CRYSTAL HILLS SUBDIVISION
PRELIMINARY OVERALL DEVELOPMENT PLAN

Re: Crystal Hills (Amending) MDP/POADP # 359-A

SUBJECT: Crystal Hills Subdivision, POADP Level 1 T.I.A.

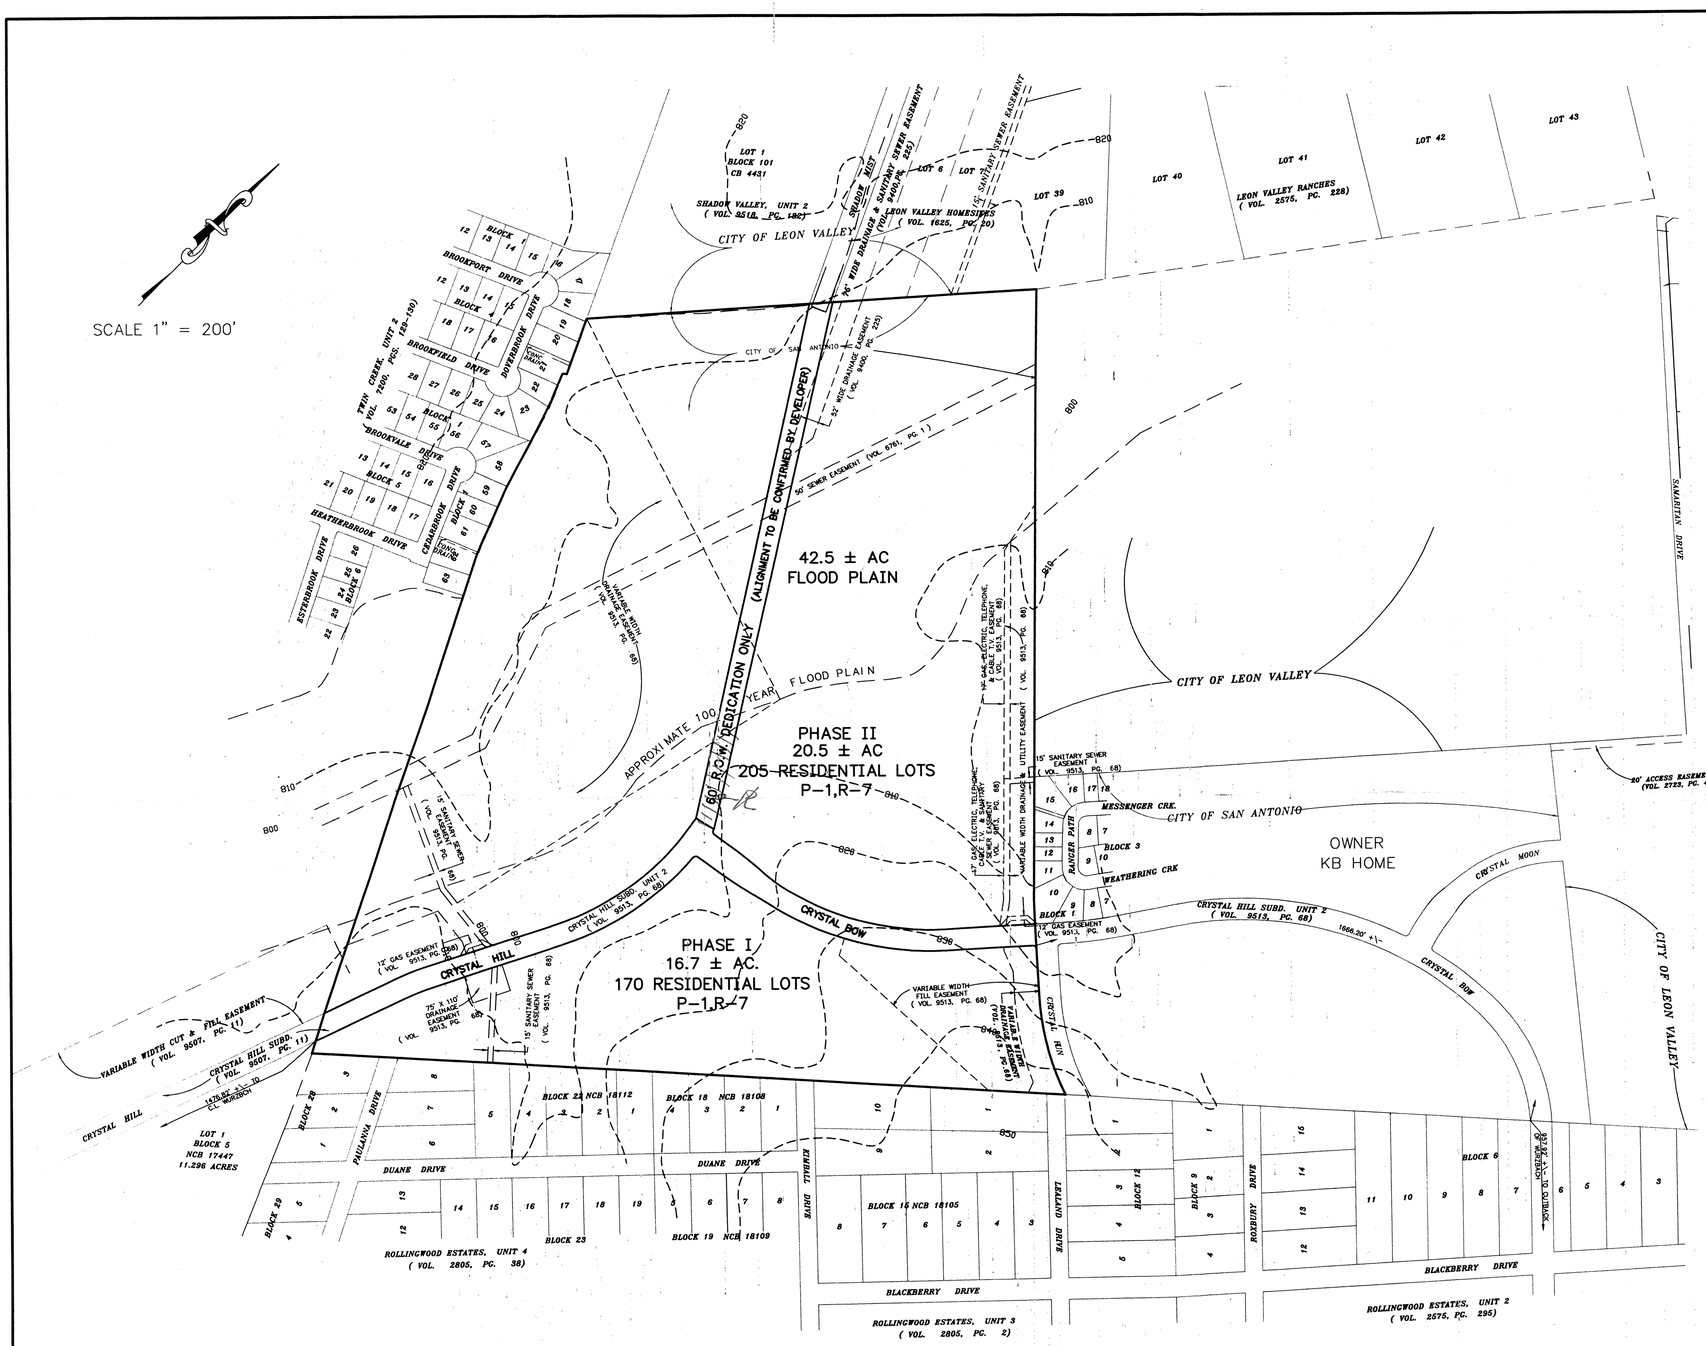
- In consideration of public safety and convenience, excessive grades by reason of topography should be avoided in street layouts and arrangements.
- Any access and R.O.W. issues along state facilities will need to be resolved with the Texas Department of Transportation (TXDOT). For information about these requirements you can contact TXDOT at 615-5814.

- Development Services, Engineering Section has indicated as part of their conditional approval, residential lots will not be allowed to front the collector streets. The sixty feet of right-of-way dedication will be for the purpose of providing the northern extension of Crystal Hill into Shadow Mist.

- This development will need to comply with tree preservation ordinance #85262. For information about these requirements you can contact Building Inspections at 207-7102.

- It will be expected that you will plat all of the property depicted in your Master Development Plan (M.D.P.) (formerly POADP), to include floodplains, drainage areas and open space.

- I would encourage you to work closely with the school district, so that they can plan accordingly.

The Development Services Engineering Division has reviewed the Level-1 Traffic Impact Analysis (TIA) for the Crystal Hills Subdivision, POADP. The analysis is in compliance with the TIA Ordinance 91700.

This property is proposed to consist of 375 single family detached homes. Based on the 6th edition of the ITE Trip Generation Manual, this property is estimated to generate 379 peak hour trips. These trips will be distributed through two collector streets, Crystal Hill and Crystal Bow. Sixty feet of right-of-way dedication has been provided for the northern extension of Crystal Hill into Shadow Mist in order to provide better access management. The City of San Antonio will continue to seek funding for construction of an all-weather road extended between Crystal Hill and Shadow Mist stub-out streets.

Note: Single family residential lots shall not front collector streets as per Ordinance 92670.
